TO: HONOURABLE MAYOR & MEMBERS OF COUNCIL
FROM: JOHN MACKENZIE, COMMISSIONER OF PLANNING
DATE: MARCH 8, 2013
SUBJECT: COMMUNICATION - COUNCIL MEETING – MARCH 19, 2013

**ITEM #17, COMMITTEE OF THE WHOLE – FEBRUARY 26, 2013
SITE DEVELOPMENT FILE DA.12.055
YORK MAJOR HOLDINGS INC.
WARD 4**

Site Plan

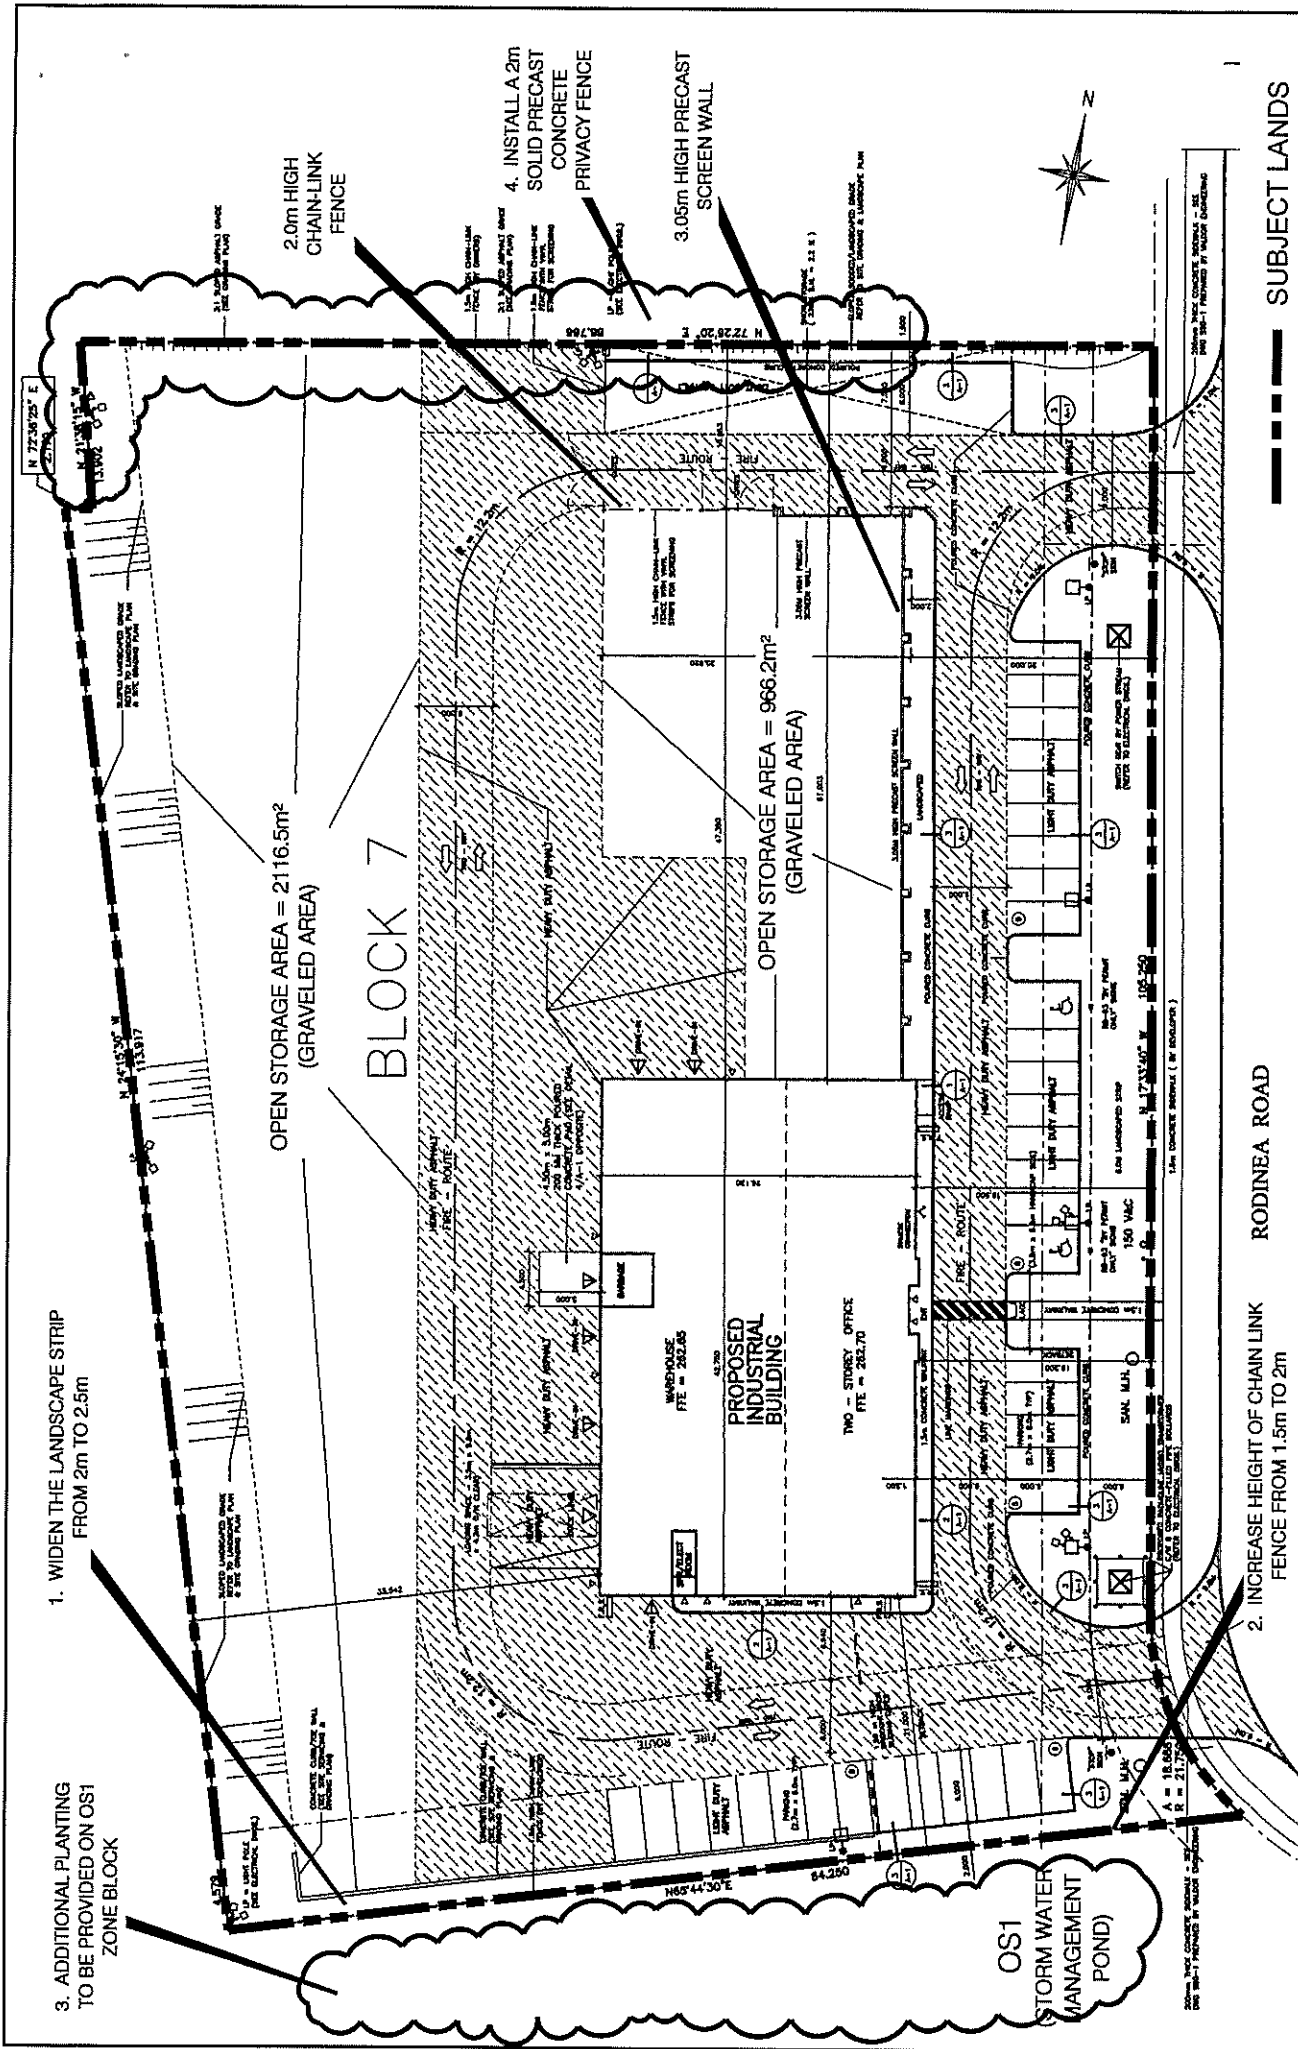
On March 1 and 7, 2013, Development Planning Staff met with the applicant to discuss possible solutions. The Owner has agreed to revise the proposed site plan and landscape plan to address the concerns raised by the Committee of the Whole as shown on Attachment #2, as follows:

1. to widen the proposed 2.0 m landscape strip on the south side of the subject lands to 2.5 m;
2. to increase the height of the chain link fence located on the south property line abutting the OS1 Open Space Conservation Zone (stormwater management pond) from 1.5 m to 2.0 m;
3. to provide additional coniferous and deciduous tree planting on the north side of the existing stormwater management pond, which will provide a natural screening of the outside storage area; and,
4. to install a 2.0 m high solid precast concrete screen fence on the north property line to screen the outside storage from the adjacent land owner.

A 1.8 m high chain link fence was constructed along the west property line (adjacent to the rail line) as a condition of the subdivision agreement and is proposed to be screened by a 6 m wide treed landscape strip. As this fence exists, the height will not be increased, however, a variance to the 2 m height requirement under the Zoning by-law will be required to be obtained through the Committee of Adjustment and a revised condition 1. a) iii) of the Committee of the Whole report in the recommendation of the Communication.
